REVISED RESPONSE TO REQUEST FOR ADDITIONAL INFORMATION

APR1400 Design Certification

Docket No. 52-046

RAI No.: 141-8098
SRP Section: 12.03-12.04 - Radiation Protection Design Features
Application Section: 12.3
Date of RAI Issue: 08/07/2015

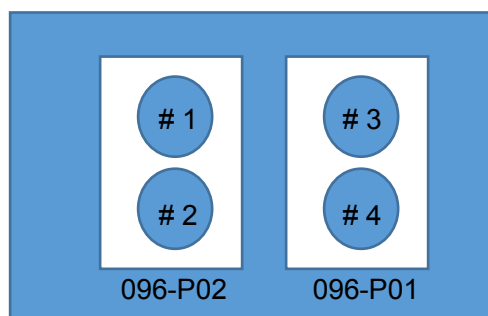
2. As shown in DCD Figure 12.3-12, Room 063-P05 is the Spent Resin Long-term Storage Tank Room, and Room 063-P06 is a room for "Future Use". Therefore, Table 12.3-4 will be updated to correct this discrepancy.
3. Two delay beds are located in a cubicle. The first and second delay beds are located in Room 096-P02, and the third and fourth beds are in Room 096-P01 as below;
